fcREQUEST FOR INFORMATION

Project Name: York Region Admin., Package D Renovation

CONSULTANTS RFI NO: TC24-114-18-X

To: Stephanie Kamburis @ G. Bruce Stratton Architects cc: Victor Chau @ York Region cc: Natalie Freitas @ York Region From: Tom Butkovic, Ivan Lulic, Jay Cowie	REFERENCE: Ducts & FC Mounting Issues Spec. Section: Drawing No.(s): M-213 Attachments: Photos
----------------------------------------------------------------------------------------------------------------------------------------------------------------------------------------------------------	-------------------------------------------------------------------------------------------------------------------------------------------------------------

SHEET NUMBER:
M-213

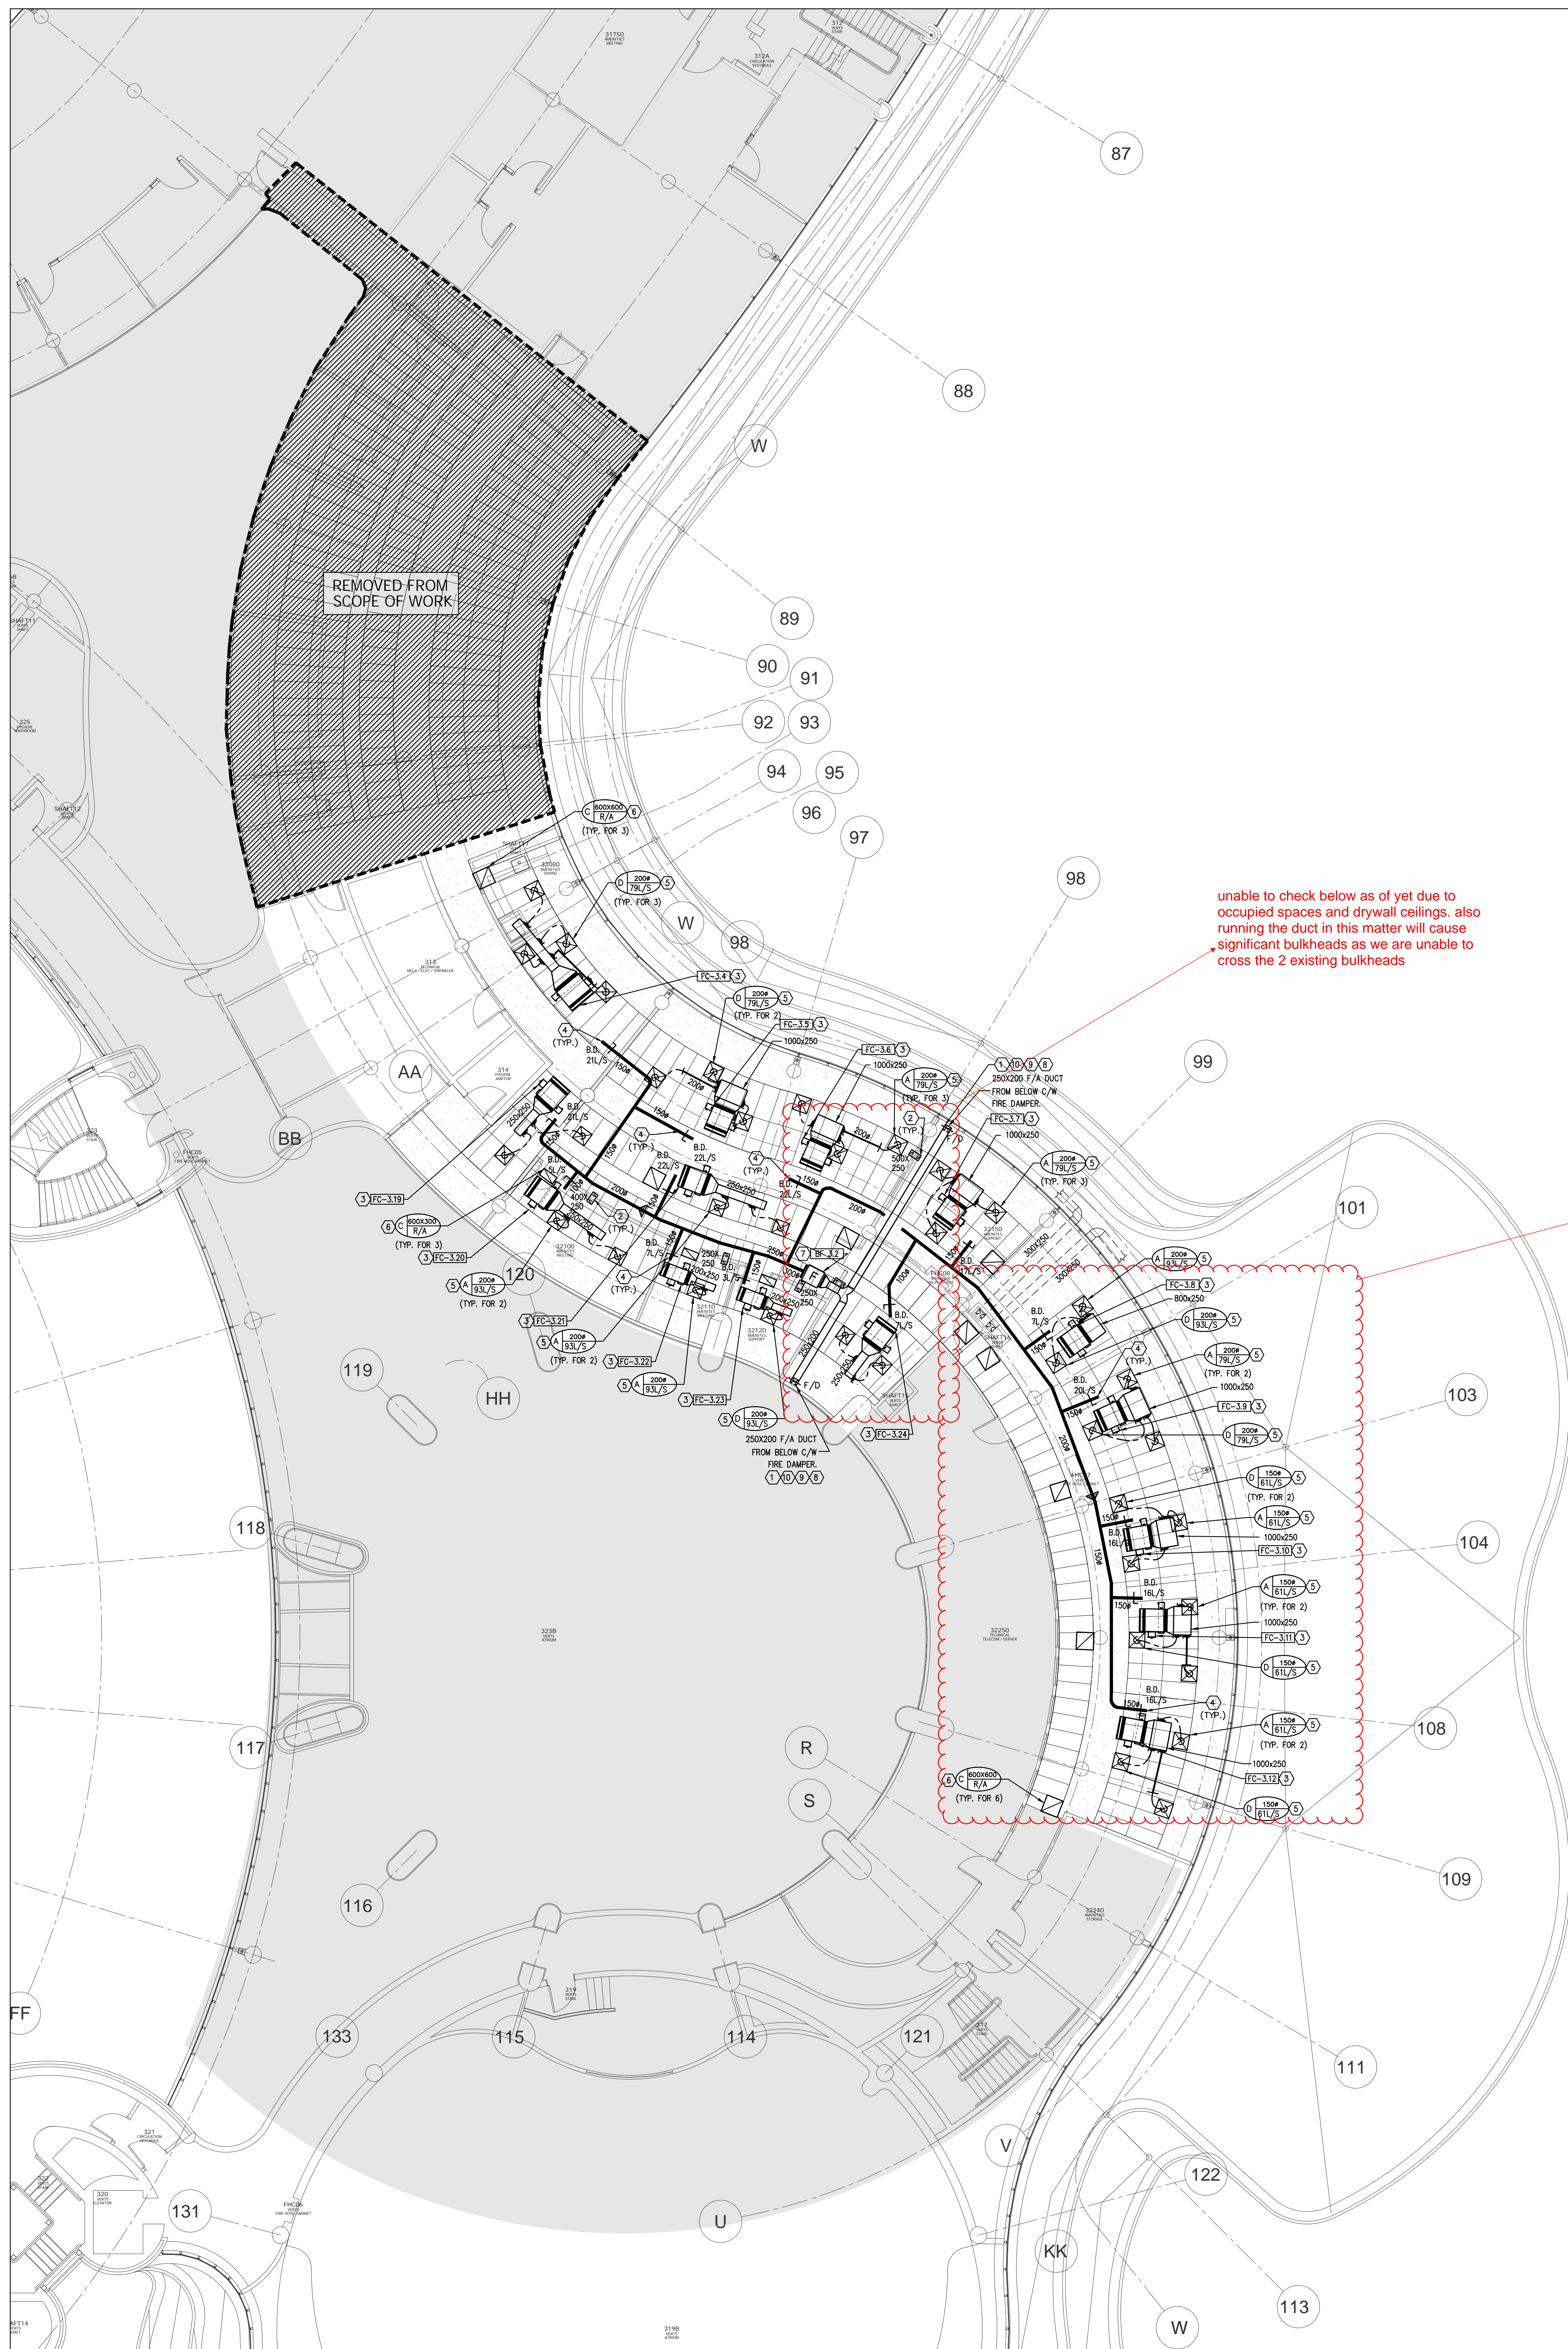
Refer attached, we are unable to run duct or mount the fan coils unless some of the existing services are moved or deleted. Kindly advise on how to proceed.

GPY Response:
1. F/A duct run: Please propose an alternate location/ duct size to accommodate current site condition for our review.
2. FCU mounting: Please refer to demolition drawings (M-205), existing abandoned services (CHS/CHR) located in ceiling space are shown to be removed in these areas. Existing services are cut back and cap near risers & NIC area.
